Response to Referee 1

Periods of constant wind speed: How long do they last in the atmospheric boundary layer?

Response to Referee 2

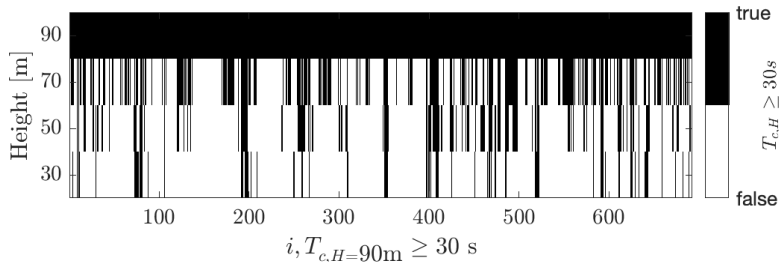
While it is an interesting topic to address, and important to highlight that the standard turbulence model is inadequate, the paper lacks proper motivation. More information would be needed to determine how these events may increase the WT loads. Are they coherent, i.e. do they occur throughout the heights enveloping the rotor area? Which design case of the IEC WT design standard do they fit into, or is a new design case needed (Introduction, L31)? How can the knowledge of these events help the WT and wind plant controller? Can an event be predicted from past few seconds of data?

You have commented on the coherence as a relevant feature of the CWS periods for assessing their potential impact on WTs. Indeed, we have investigated coherent CWS events through the analysis of the FINO1 wind measurements at different heights (see details of the data in Sec. 2.2 of the manuscript). The results of our preliminary investigations suggest that the periods of CWS appear localized at different heights. An example of the analyses is shown in Fig. 1 in this document. Nonetheless, further studies from meteorological mast arrays (e.g., GROWIAN data or the WiValdi test site) should shed more light on the spatial coherence of these events.

In this case, 37% of the events at 90m are happening simultaneously at 70m. This number decreases to 11% when comparing the periods of CWS between 90m and 30m. The same evaluation for coherent events has been performed conditioned by different values of T_{min} and reference heights \tilde{H} .

Additionally, we now have provided details about the coherence investigation in the Appendix G: “Spatial coherence of T_c ” of the manuscript, including Fig. 1 shown above.

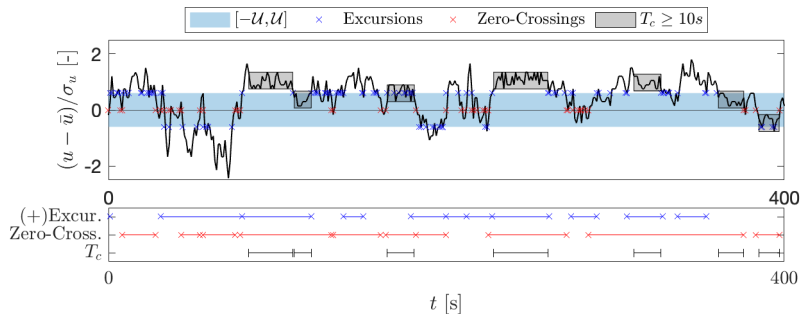
[L.1: this is not a "non-investigated" topic; see e.g. Majumdar's "Persistence in nonequilibrium systems" \(1999\), or in the ABL, e.g. Chowdhuri, et al. \(2020\), <https://doi.org/10.1063/5.0013911>.](#)

l.81-82: note that this (and Fig.1) is essentially the (reverse of) the generalized gust description of L.Kristensen et al (1991) following from Rice (1945).

However, even though their definition may be similar with respect to the periods of CWS, they are not directly related. Please see Fig. 2. In the top-plot, the zero-crossings of the zero-mean and normalized time series of $(u(t) - \bar{u})/\sigma_u$ are shown by red crosses. In [Chowdhuri et al., 2020], persistence is defined as the inter-arrival times between the zero-crossings. Comparatively, the grey rectangles mark the measured periods of CWS ($T_c > 10$ s). For a clearer comparison, the bottom-plot shows the duration of the inter-arrival times between the zero-crossings (red lines). As observed, persistence events and periods of CWS are not the same. A period of CWS might enclose several zero-crossings, as well as several periods of CWS might be embedded inside an individual inter-arrival between zero-crossings.

We have now included the Appendix A: “Periods T_c vs persistence events” in the manuscript. There we incorporate Fig. 1 shown above in this document.

In the top-plot of Fig. 2, the blue area defines the thresholds $\pm\mathcal{U}$ for considering the extreme winds (also called gusts, or excursions). The blue crosses depict the times when such thresholds are crossed. Again, periods of CWS (T_c) larger than 10s are marked by the grey rectangles. For comparison, the threshold \mathcal{U} for the excursions is defined as twice the threshold ε . In that way, a period T_c inside $\pm\varepsilon$ would contain the size of the fluctuations defined inside the ranges $(0, \mathcal{U})$ or $(-\mathcal{U}, 0)$. In a similar way as depicted by the red lines for the inter-arrival times between zero-crossings (see response to your SPECIFIC COMMENT on l.1), the lengths of the inter-arrival times between excursions are shown by blue lines in the bottom-plot. In this case, the inter-arrival times are considered only for the positive threshold \mathcal{U} . As observed, the periods of CWS are not equivalent to the inter-arrival times between excursions. A period of CWS might enclose several excursions, as well as several periods of CWS might be embedded inside an interval between two consecutive excursions.
